# Access Compliance Report

## Public Rights-of-Way

Intersection ID: 51371	Main Street: UNIVERSITY_POINTE_BV	Cross Street: N_TRYON_ST	Location: NE
ADA ID: 69C2BB299052	Ramp Type: Perp	Initial Pass/Fail: Fail	Overall Compliance: No
Severity Score: 10			
Codes/Mitigation Info/Possible Solution		Field Measurements/Component Compliance

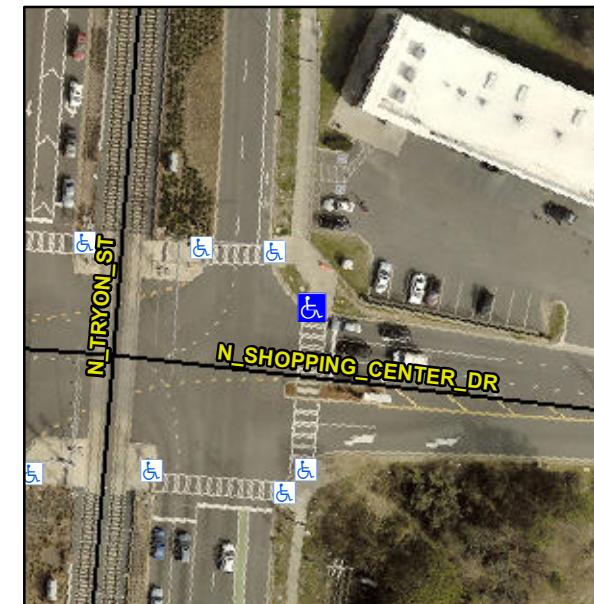
**Not Found, R304.5.1**

Compliance	Description	Data	Compliance	Description	Data
N/A	Ramp Length (in)	96.0	Yes	Ramp Slope (%)	5.2
No	Ramp Width (in)	47.0	Yes	Ramp XSlope (%)	2.1
N/A	Flare Type LT	N/A	N/A	Flare Type RT	N/A
N/A	Flare Slope LT (%)	N/A	N/A	Flare Slope RT (%)	N/A
N/A	Flare Traversable LT?	N/A	N/A	Flare Traversable RT?	N/A
N/A	Landing Length (in)	N/A	N/A	DWS Provided?	N/A
N/A	Landing Width (in)	N/A	N/A	DWS Contrast?	N/A
N/A	Landing Slope (%)	N/A	N/A	DWS Length (in)	N/A
N/A	Landing X Slope (%)	N/A	N/A	DWS Full Width?	N/A
N/A	Landing Curb? (Y/N)	N/A	N/A	DWS Offset (in)	N/A
N/A	Shared Landing?	N/A			
N/A	Gutter Ponding?	N/A	N/A	Gutter Slope (%)	N/A
N/A	Gutter Lip Ht (in)	N/A	N/A	Gutter X Slope (%)	N/A
N/A	Painted X Walk1?	No	N/A	Painted X Walk2?	N/A
	X Walk 1 Direction	To S		X Walk 2 Direction	N/A
N/A	X Walk 1 Width (in)	N/A	N/A	X Walk 2 Width (in)	N/A
	X Walk 1 Slope (%)	2.1		X Walk 2 Slope (%)	N/A
	X Walk 1 X Slope (%)	3.8		X Walk 2 X Slope (%)	N/A

**Remove & Replace Entire Ramp.**
